BEFORE AN INDEPENDENT HEARING COMMISSIONER FOR WAITOMO DISTRICT COUNCIL

IN THE MATTER of an application by Taumatatotara Wind Farm

for the Taumatatotara Wind Farm

Supplementary Legal Submissions on behalf of the Director-General of Conservation *Tumuaki Ahurei* – Points raised by the Commissioner at hearing

Appendix 1 – Diagram from evidence of Glenn Starr

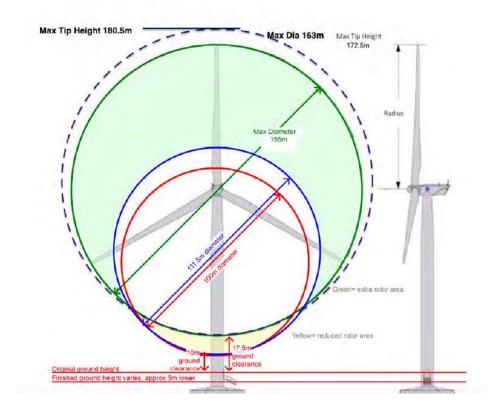
- 32. While acknowledging the information gaps, the ecological evidence presented on behalf of the Director-General is that the proposed variation creates a real risk of harm to bats with 'the potential to cause more damage to bats'¹⁰ than the consented activity, due to the increased size of the remaining turbines. The Department refers the Commissioner in particular to the evidence presented at hearing that demonstrates the massive size increase of each individual turbine, in terms not just of height but increased rotor length and sweep.¹¹ The diagram provided in Glenn Star's evidence¹² demonstrates this difference in pictorial form and is **attached** to these further submissions as Appendix 1. The Department submits that on that basis, it would be open to the Commissioner to conclude, having now seen the evidence from the parties, that the application should in fact be progressed pursuant to section 88 rather than section 127.
